TO: THE AUSTRALIAN SENATE
Rural and Regional Affairs and Transport
References Committee

Reference: Plantations forests industry

FURTHER SUBMISSION FOLLOWING COMMITTEE'S VISIT

COUP LA028A

Figure 1. Sketch map of coupe showing numbered complaints (1-7) and other features noted (9-11). Note that complaint 8 was a general one and is not shown on the map.

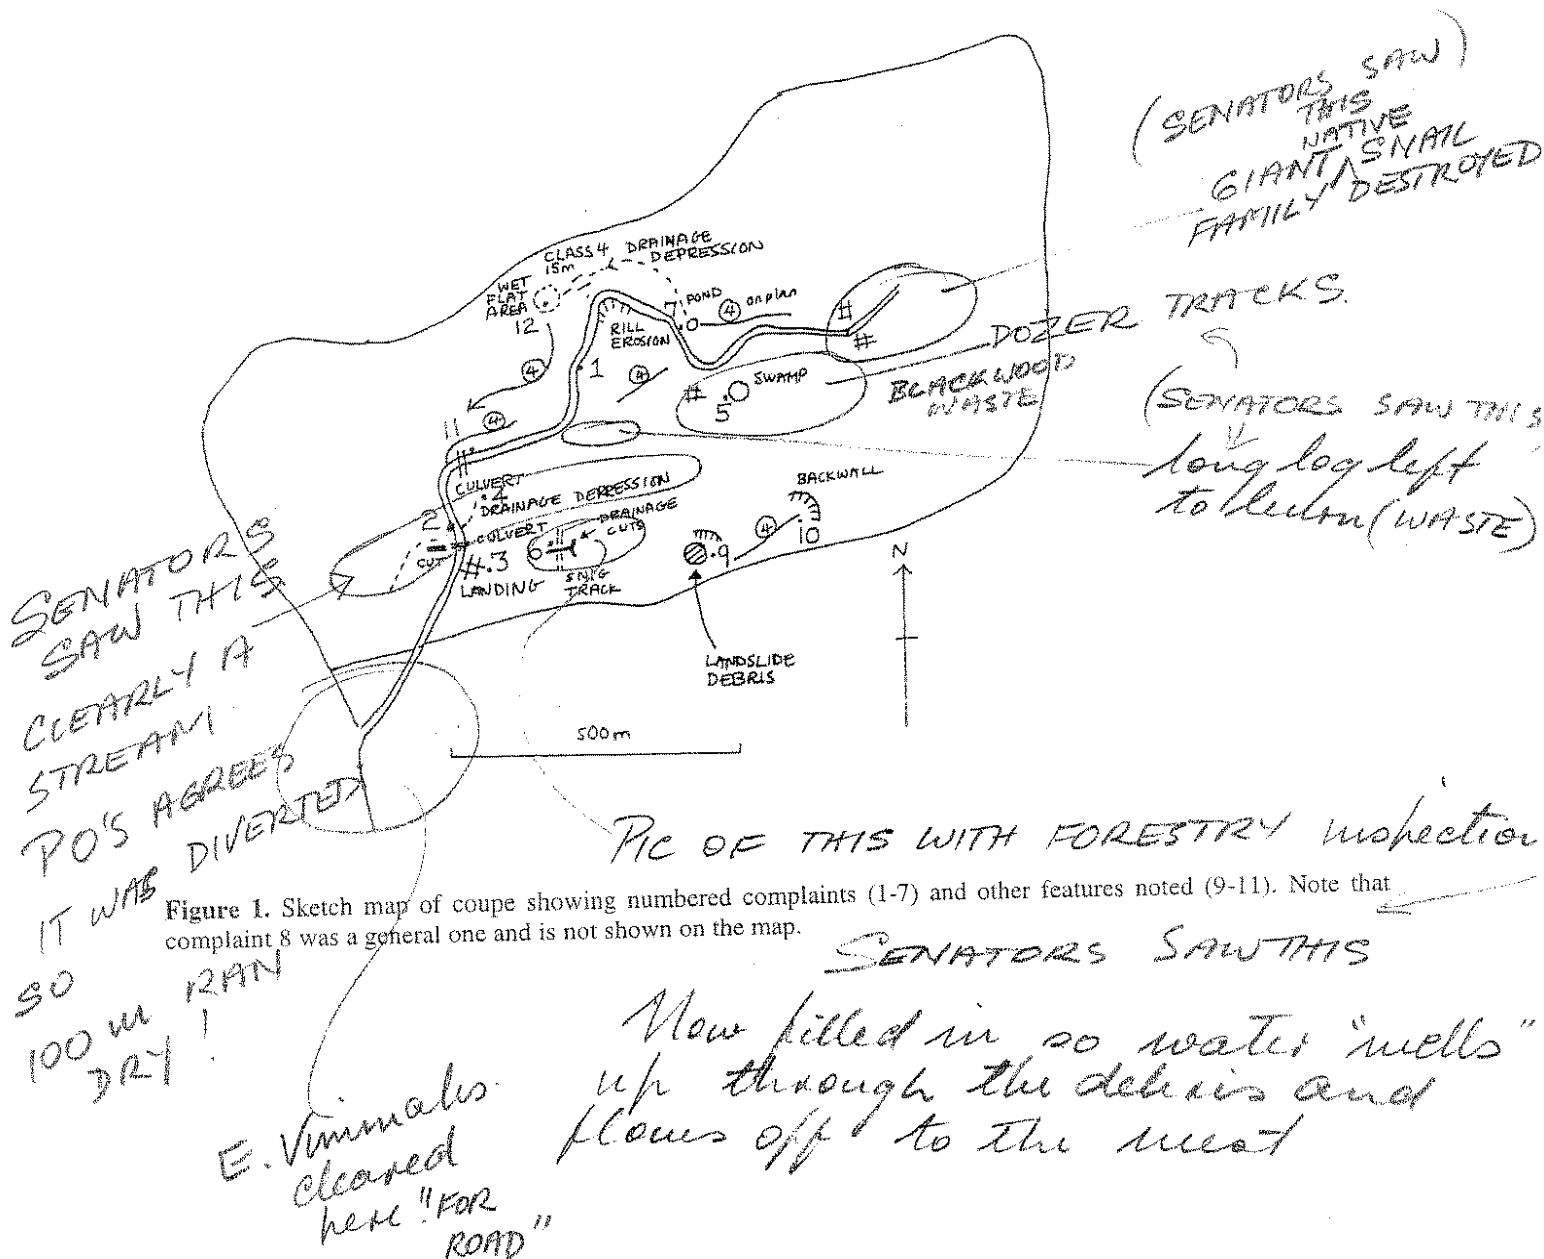
Complaint 1. The road has cut through an old landslide, disturbing a spring, which has caused a landslip requiring expert consultation for remedial repairs, not all of which have been followed according to instructions

Complaint 2. Road re-routing Class 4 stream and filling of bed with soil and debris

Complaint 3. Landings rutted and not corded. Landings located over Class 4 streams and stream re-routed.

Complaint 4. Streams filled with tree heads and coupe debris. Deep rutting in streams. No marking of buffer zones. Deeply rutted crossing with no cording. Multiple crossings on streams.

The Board believes that the feature is a drainage depression. A significant amount of water was observed flowing in the drainage depression during two inspections in October 2002. This followed record or near record rainfall in September, and the effect of harvesting which was to reduce transpiration and hence increase runoff, and to intersect some sub-surface flow, bringing it to the surface. Forestry Tasmania has agreed to place another culvert across the road where the main flow of the drainage depression into the table drain was observed.

In addition the cut directing the water exiting from the existing culvert at site 2 onto a rise should be modified to direct the water into the drainage depression to the north of the cut. This can be achieved by shallow trenching with an excavator. In general artificial cuts to redirect water on basalt talus terrain should be avoided as they risk saturating soils that are not normally saturated, thereby causing instability.

Rutting on landings was observed to be less than 20 cm. The landing at site 3 was in a slight depression and could have been better located.

Figure 2. The small landslide (roadside batter collapse) at complaint site 2 has been successfully stabilised by installing drainage and armouring the backwall of the collapse with boulders.

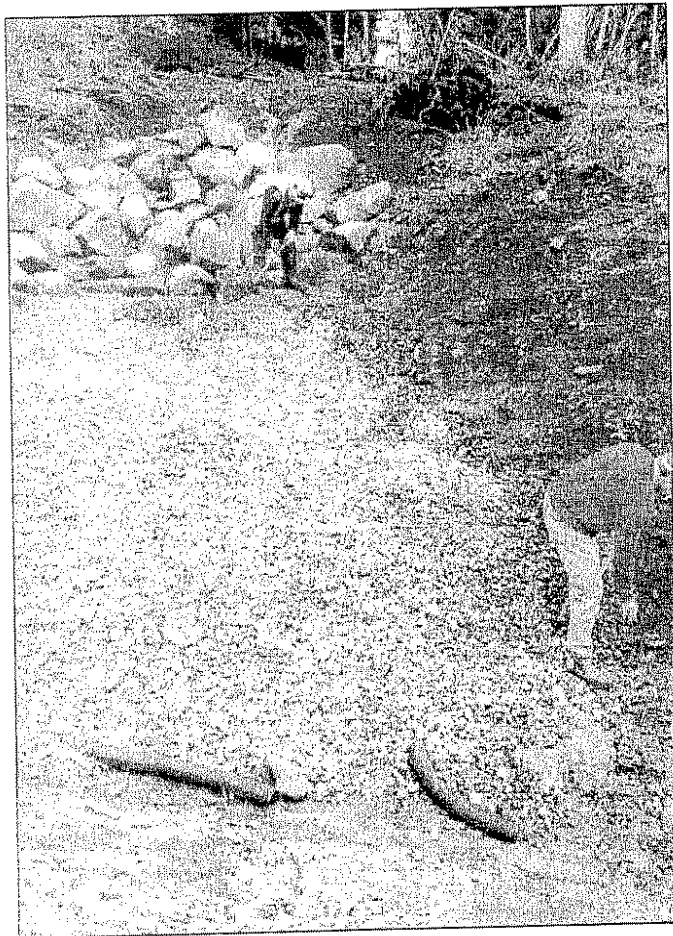
This is all 'active' land with a sea anemone geology map shows this. An experienced forester should recognize this!

Pat O'S does NOT agree.
This is clearly a stream - supporting water flow ALL year - including the driest part of summer. Rushes grow along the banks where disturbed.

The roadside batter collapse was the subject of a report by P.D. McIntosh on 20 February 2002. The remedial measures taken broadly follow the recommendations of the report and have been successful in stabilising the land behind the small landslide, through a combination of drainage and armouring the landslide face with boulders (Figure 2). The minor divergences from the recommendations of the report are immaterial.

Figure 4. Wet flat area at site 12. The drainage of this area would be improved by removing the light logging debris.

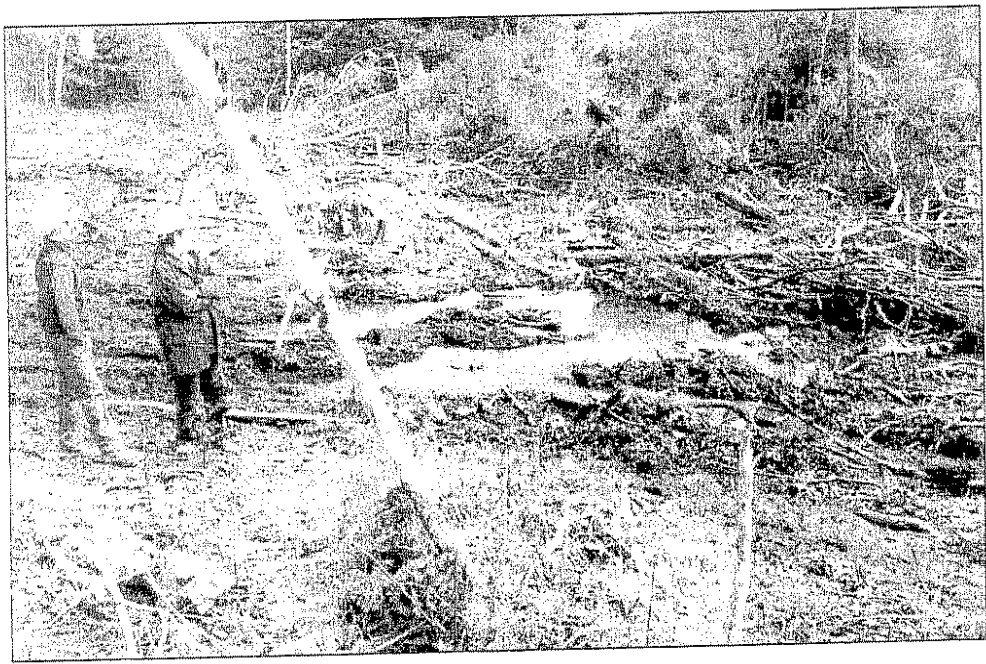
what?

Water from the drainage depression in the north of the coupe discharges water onto a broad flat area. Light logging debris impedes drainage (Figure 4). This logging debris needs to be removed with an excavator so that natural drainage is restored.

Forest Practices Plan Key GPS0210
Locality LORINNA
Coupe LA0284 Scale 1:10,000

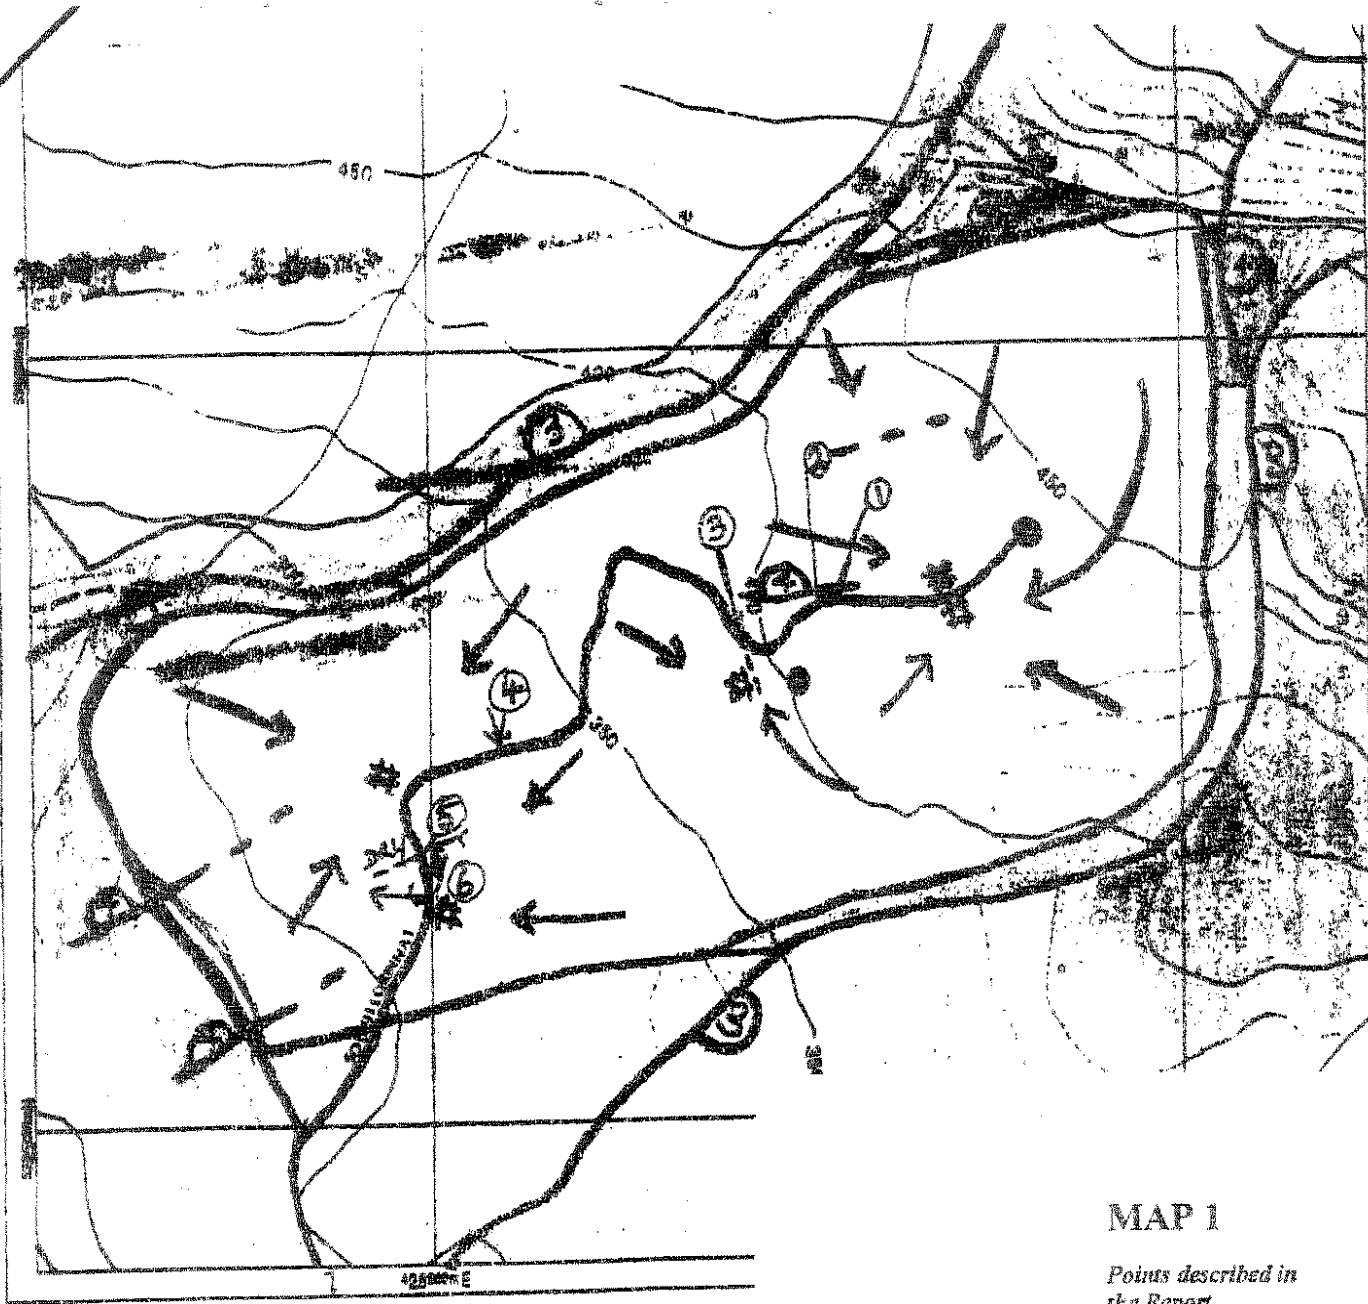
* → The Code requirements (see the 6th dot point on page 45) that understorey vegetation damage should be minimized seems to have been ignored.

Swampy zones should have had greater protection from recent firebreak works that have piled flammable debris against streamside and swamp vegetation. As previously noted runoff bars (or grips) are poorly constructed due to the lack of drainage outlets.
